TO: All Vendors
Tywana Scott, Quality Assurance Analyst
Herbert Judon, Jr., Augusta Regional Airport
FROM: Geri Sams
Procurement Director
DATE: March 13, 2023
SUBJ: Addendum 2 - New Bid Opening Date, Clarifications to the Specifications and Responses to Vendor's Questions
BID ITEM: Bid Item #23-131 Construct Taxiway G for Augusta, GA - Augusta Regional Airport

ADDENDUM NO. 2

SHEET CONTENTS
ELECTRICAL LAYOUT

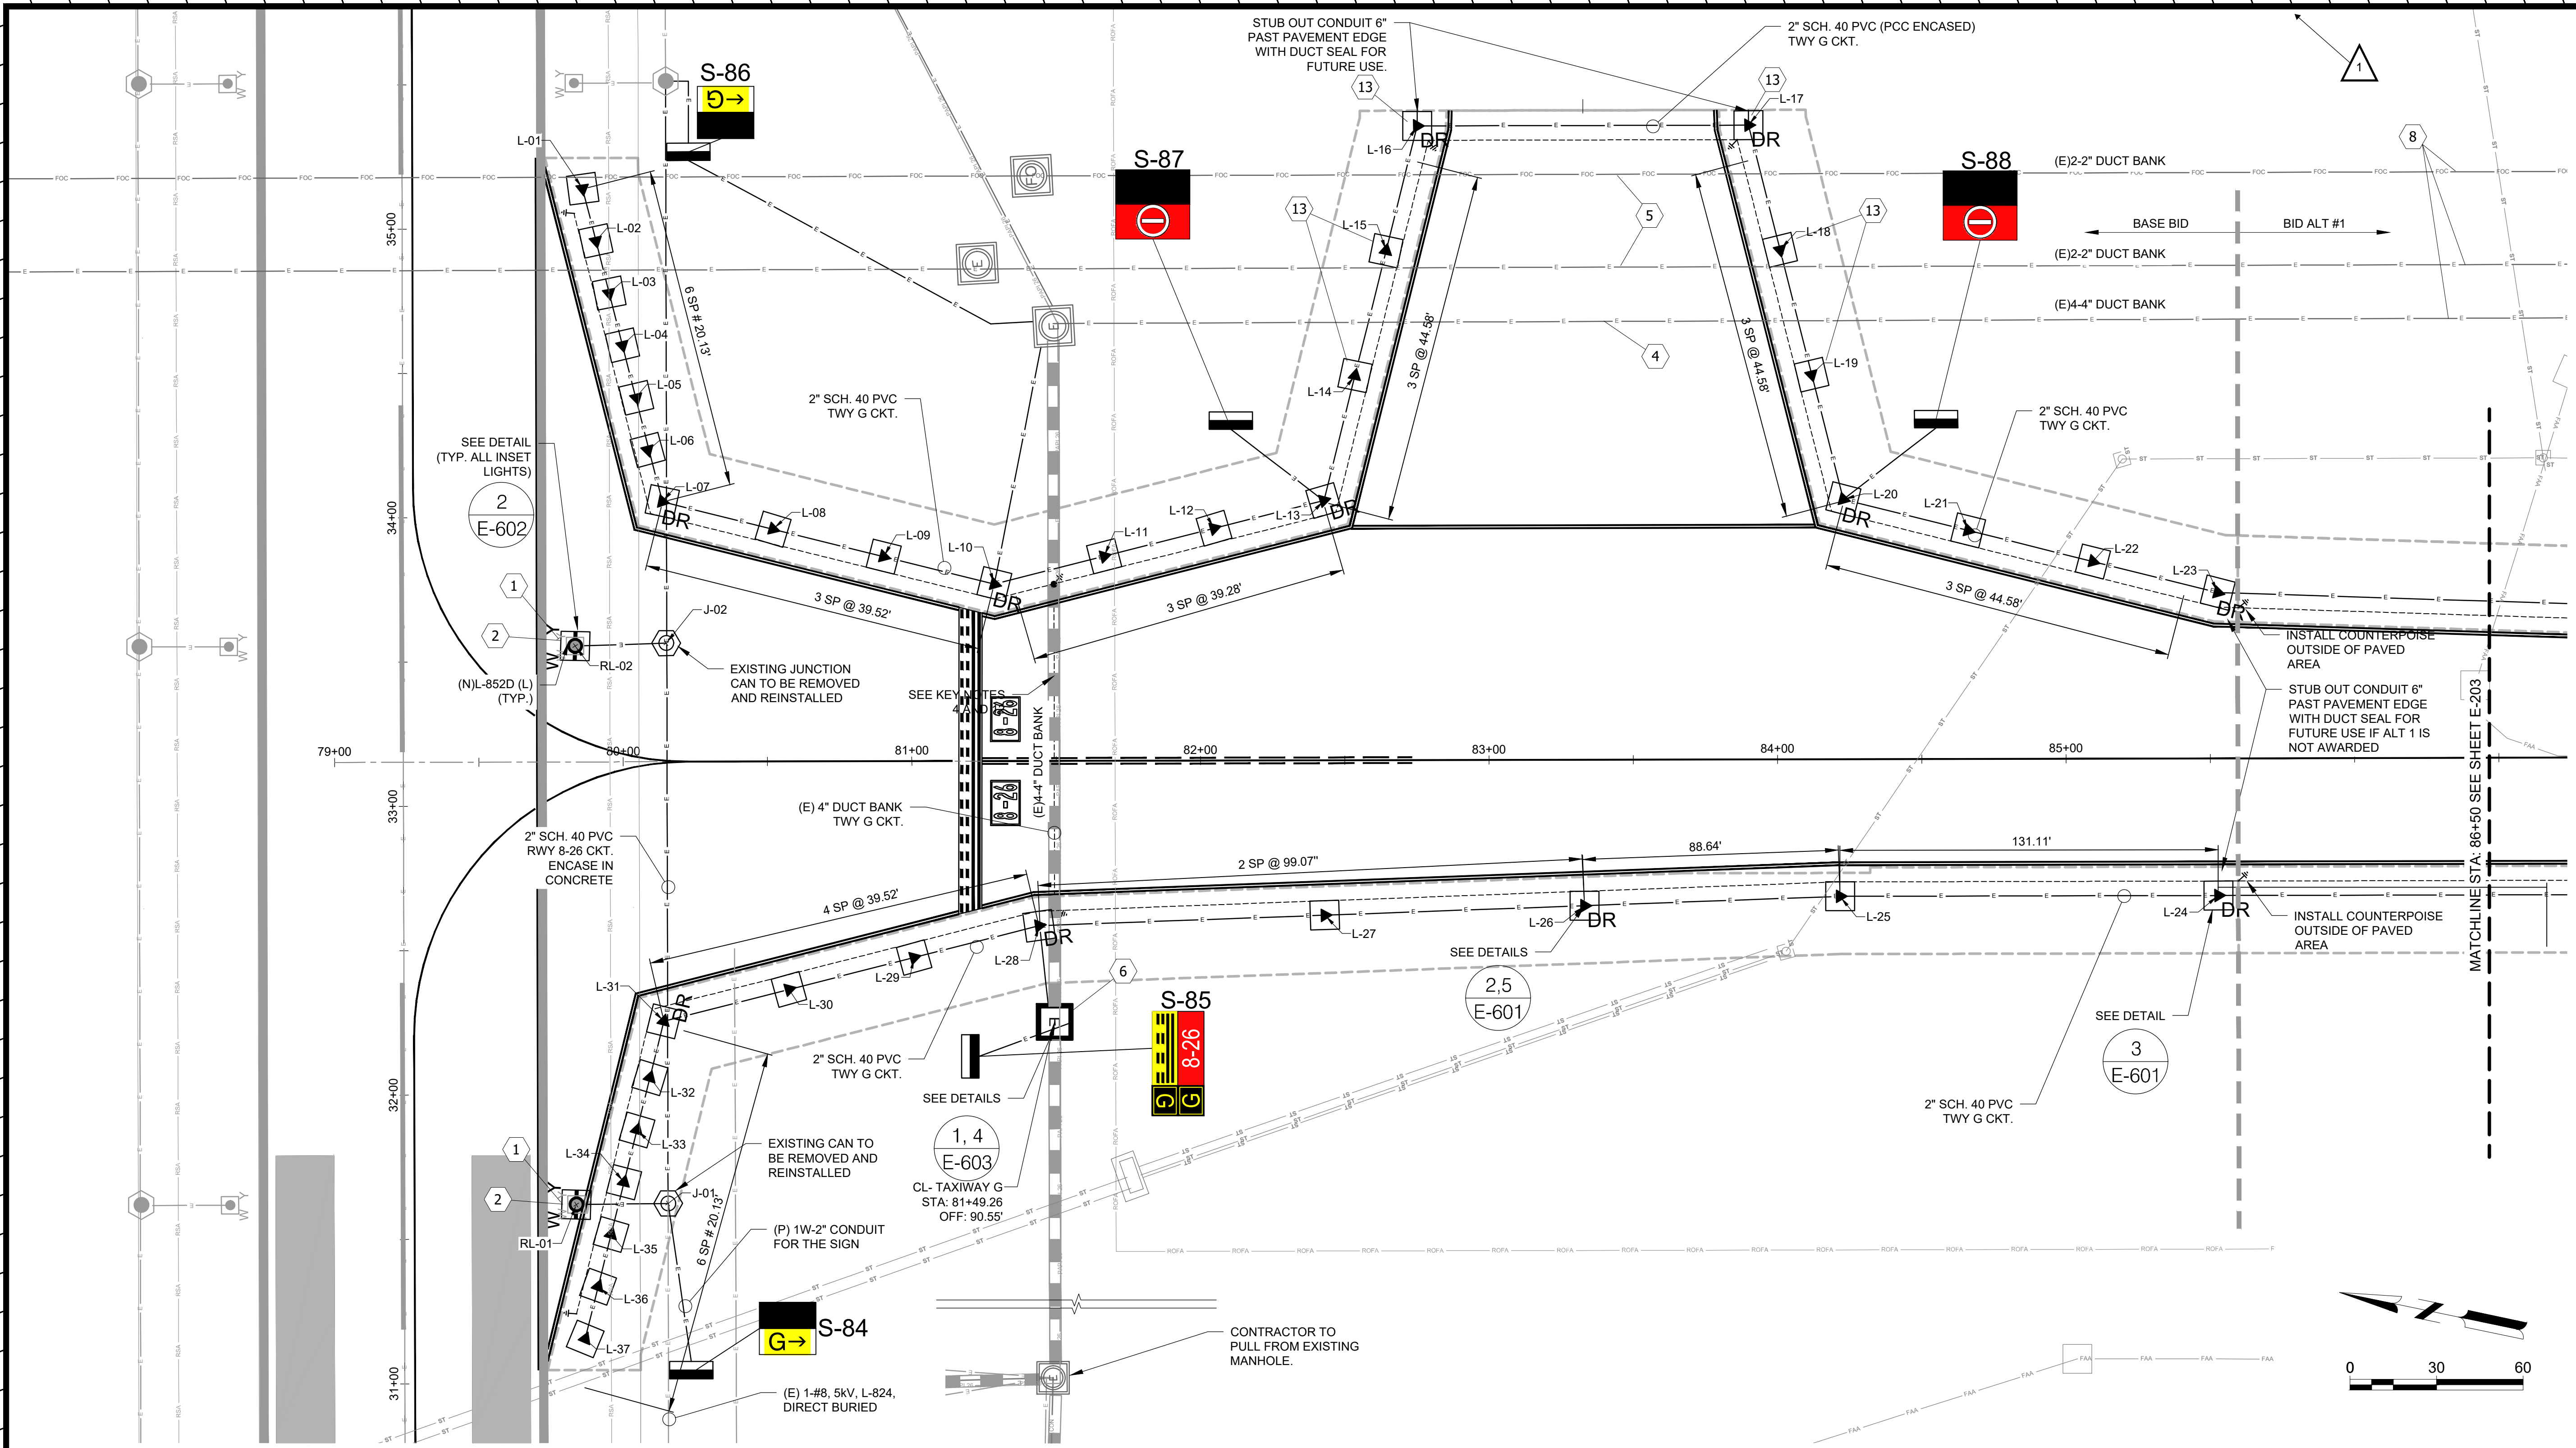
2. **Sheet E-201: Revised sheet to address taxiway edge light callouts. Delete sheet E-201 and replace with page E-201 attached to this Addendum No. 2.**
3. **Sheet E-205: Revised sheet to address AWOS cabling callouts. Delete sheet E-205 and replace with page E-205 attached to this Addendum No. 2.**

Response: The Non-Lighted Taxiway End signs are reference per line-item L-125.6.
10. Question: On E-201, Junction cans are paired with a note that says "Existing (junction) can to be removed and reinstalled". Is the intent for the contractor to reinstall the existing junction cans, or is the intent to replace the existing junction cans with new junction cans?

Response: Contractor shall reinstall existing junction can in location(s) shown on sheet E-201.
11. Question: On plan page E-203, taxiway lights L-46, L-47, L-48, L-50, & L-51 are paired with Key note 13 which describes installing a blank lid and delivering the light fixture and transformer to the airport for later use. Should taxiway light L-49 be labeled with key note 13? Also, should lights L-14, L-15, L-16, L-17, L-18, & L-19 on plan page E-201 be labeled with key note 13? Are the blank lids intended to be incidental to taxiway edge light line items? To avoid confusion, can an additional line item be made for these blank lids?

SHEET CONTENTS
ELECTRICAL LAYOUT

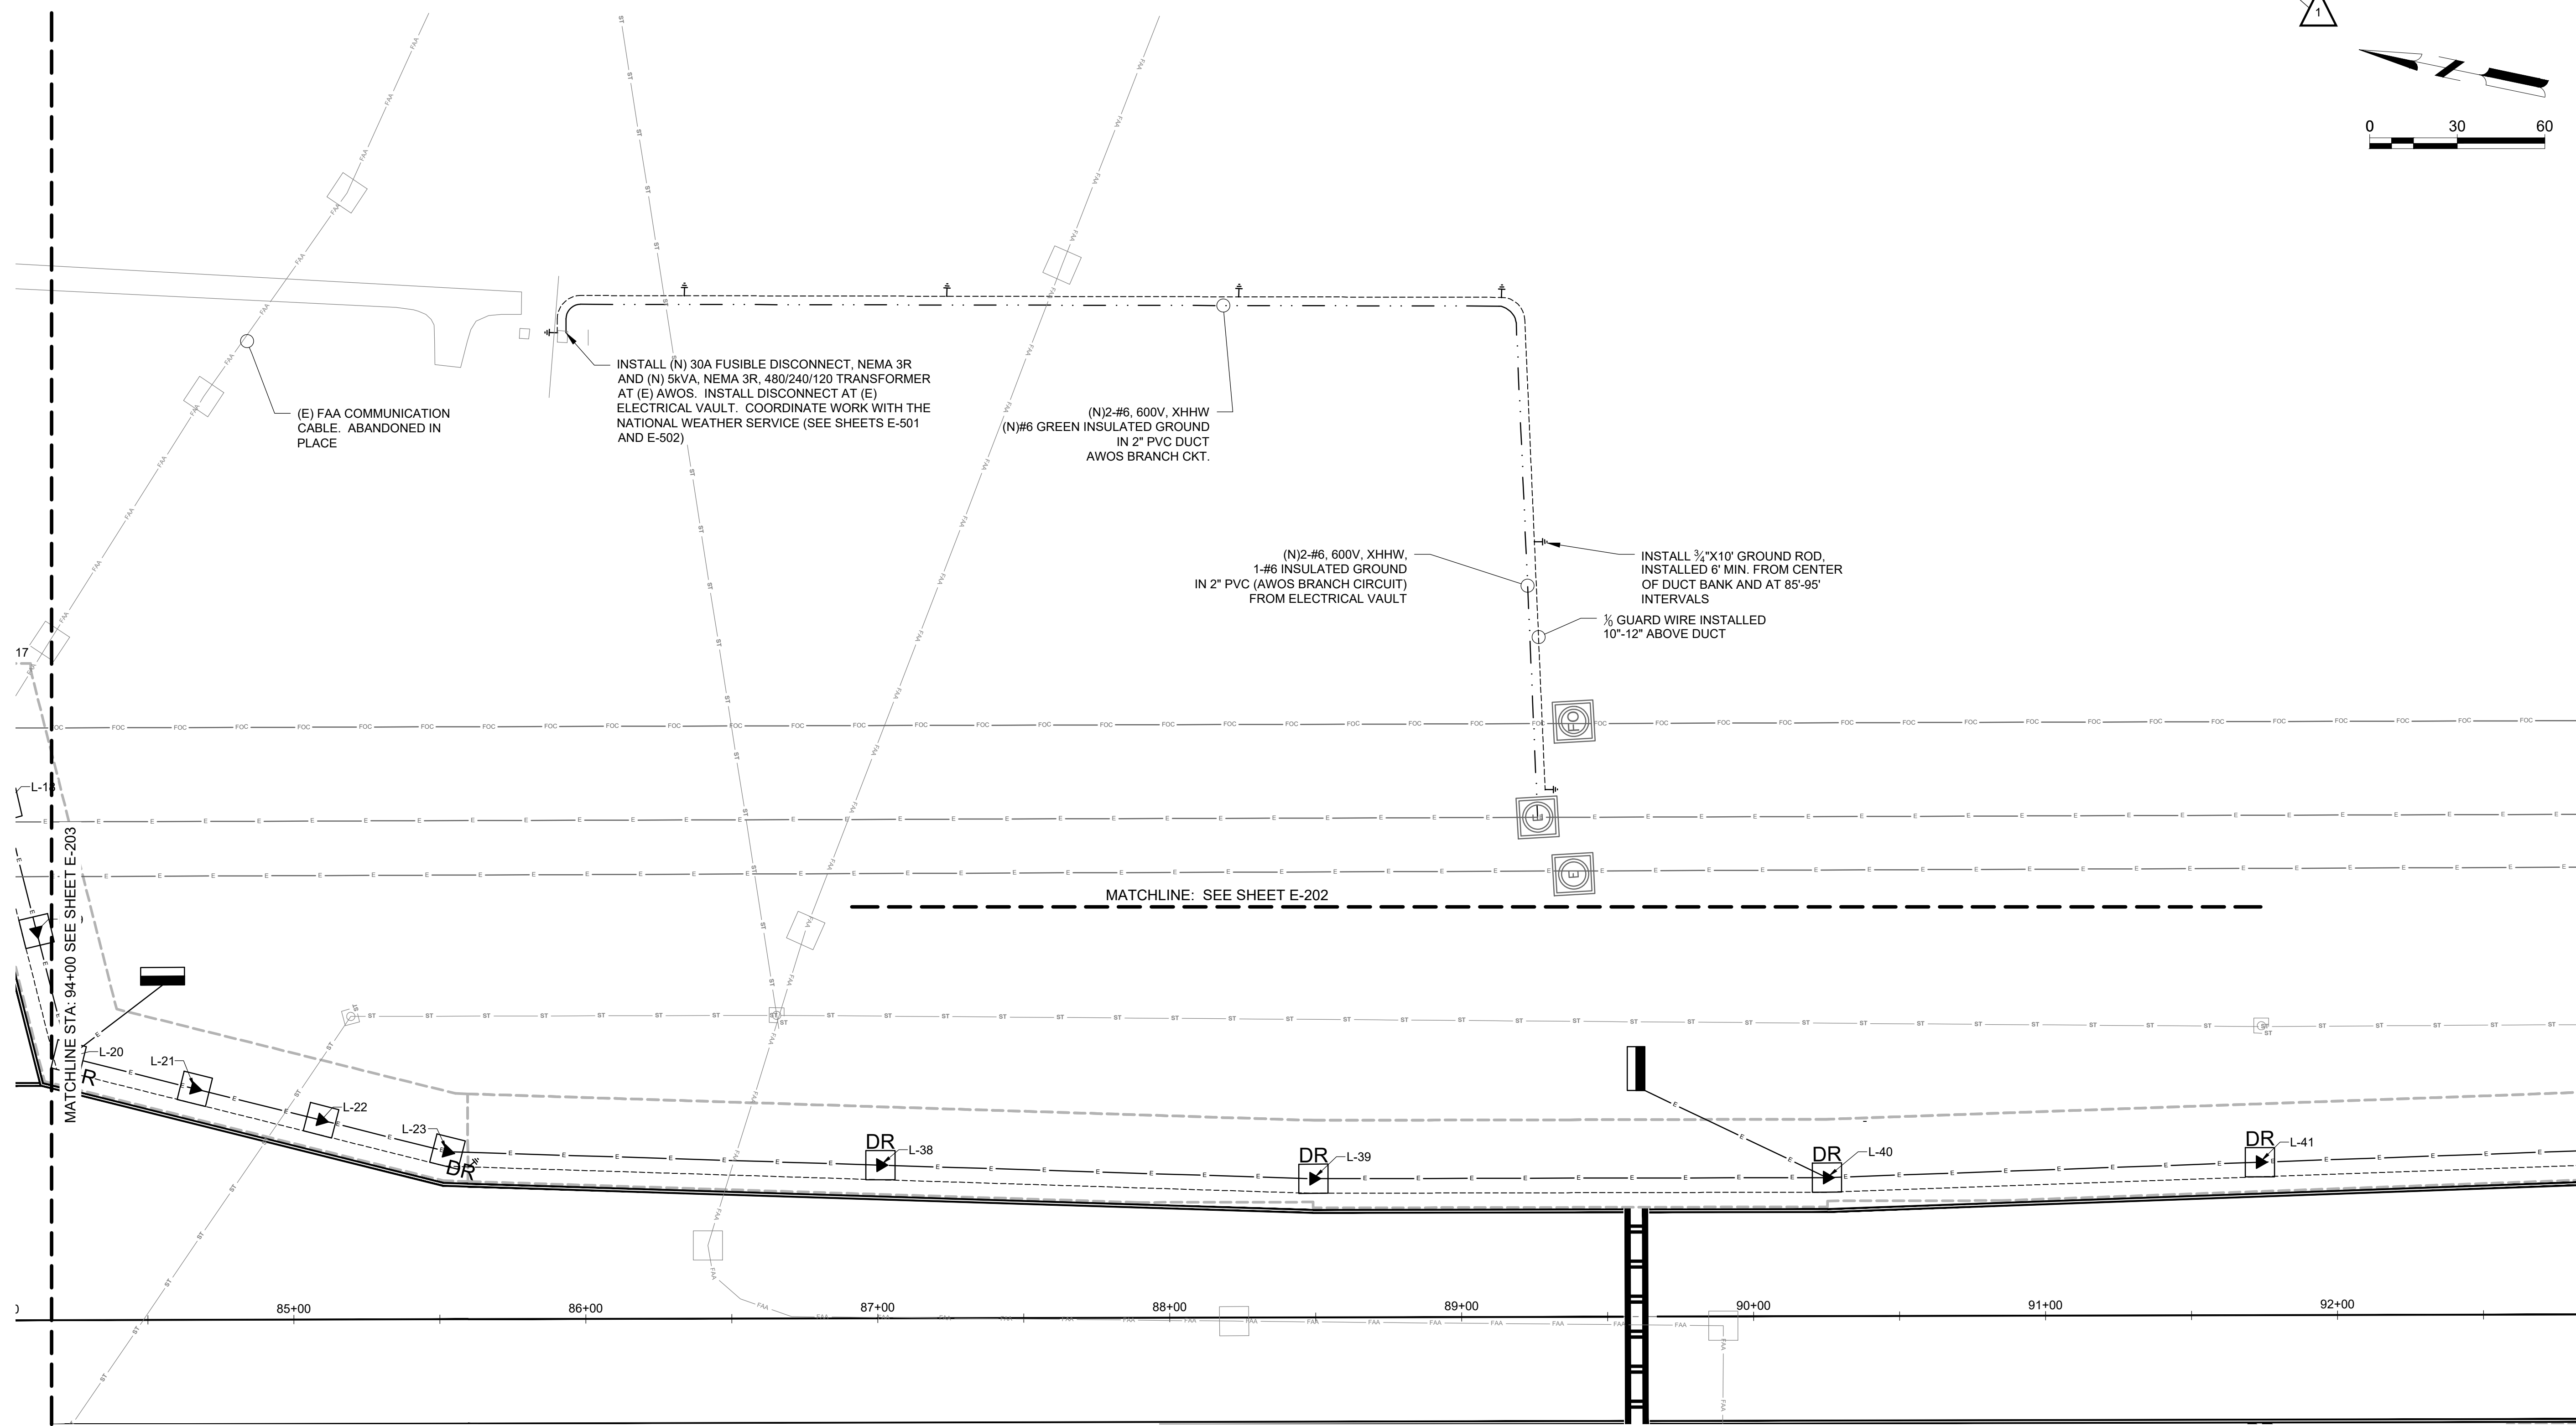
2. Question: Per Addendum 1 Q&A #59, the contractor will bill the AWOS cable under line-item L-108.4 "No.6,600V, XHHW Cable, Installed in Trench, Duct Bank or Conduit". The plans have the AWOS circuitry labeled as no.4, 600v, XHHW w/ #6 ground. How does this relate to the L-108.4-line item? Please also check the quantity of 525ft vs the distance from the lighting vault to the AWOS site.

3. Question: On plan page E-205, the AWOS conduit from the existing MH to the AWOS is labeled as both 4" PVC and 2" PVC. Is this conduit existing? If it is not existing, what size conduit should the contractor install? If 4" PVC should be installed, what line item should it be billed under?

Response: The plans have been revised to show the proposed cable and conduit as No. 6, 600V, XHHW Cable. Please refer to Construction Drawing change 3 and Project Manual Change/Clarification 1 as referenced above.

Response: Contractor shall install new 2" PVC as shown on plan sheet E-205 back to existing electrical manhole. Please refer to Project Manual Change/Clarification #1 as referenced above and Construction Drawing change #3.
